Access Compliance Report Public Rights-of-Way (Curb Ramps)

Main Street: GLOXINIA_ST Cross Street: SKLAR_ST Location: NW

ADA ID: RPAT211102111525 Ramp Type: Type 1 - Perpendicular Diagonal Initial Pass/Fail: Pass Overall Compliance: No Severity Score: 25

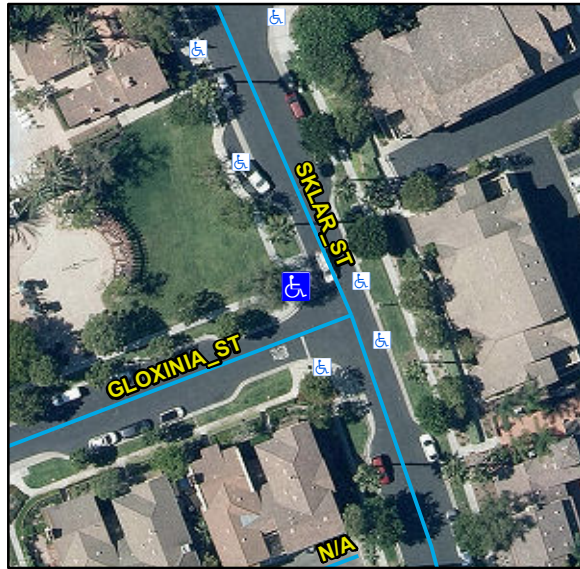
Compliance	Description	Data	Compliance	Description	Data
N/A	Ramp Length (in)	90	N/A	Flare Type LT	
Yes	Ramp Width (in)	48			Sloped
Yes	Ramp Run Slope (%)	3.4	Yes	Flare Slope LT (%)	4.1
Yes	Ramp Cross Slope (%)	0.2	N/A	Flare Traversable LT	Yes
N/A	Landing Present	No	N/A	Flare Type RT	
N/A	Landing Length (in)	N/A			Sloped
No	Landing Width (in)	N/A	Yes	Flare Slope RT (%)	3.2
No	Landing Run Slope (%)	N/A	N/A	Flare Traversable RT	Yes
No	Landing Cross Slope (%)	N/A	No	DWS Provided	No
N/A	Landing Movement Obstructed?	Yes	N/A	DWS Contrast	N/A
	Landing Movement Type	Curb	N/A	DWS Length (in)	N/A
N/A	Landing Shared	N/A	N/A	DWS Full Width	N/A
N/A	Clear Space	Yes	N/A	DWS Offset Left (in)	N/A
N/A	Clear Space To Crosswalk (in)	48	N/A	DWS Offset Right (in)	N/A
N/A	Marked Crosswalk 1	No	N/A	Marked Crosswalk 2	No
	Crossing 1 Direction	S		Crossing 2 Direction	E
	Marked Crosswalk 1 Width (in)	N/A		Marked Crosswalk 2 Width (in)	N/A

N/A	Ramp Inside Crosswalk 1	N/A	Yes	Ramp Inside Crosswalk 2	N/A
	Crossing 1 Slope (%)	1.7		Crossing 2 Slope (%)	2
	Crossing 1 Cross Slope (%)	0.6		Crossing 2 Cross Slope (%)	1.1
Yes	Gutter Ponding	No	No	Curb Slope	11.5
Yes	Gutter Lip Height (in)	0		Road Run Slope (%)	2
No	Gutter Run Slope (%)	9		Road Cross Slope (%)	0.9
Yes	Gutter Cross Slope (%)	0.8			
Yes	Overall Surface Condition: Acceptable		No	Perp Joint Present	No
	Cross Gutter Present?	No		Spandrel Present?	No
	Replace Cross Gutter?	N/A		Replace Spandrel?	N/A

Remove & Replace Curb Ramp With Two New Directional Ramps or Equivalent. Remove & Replace Gutter.
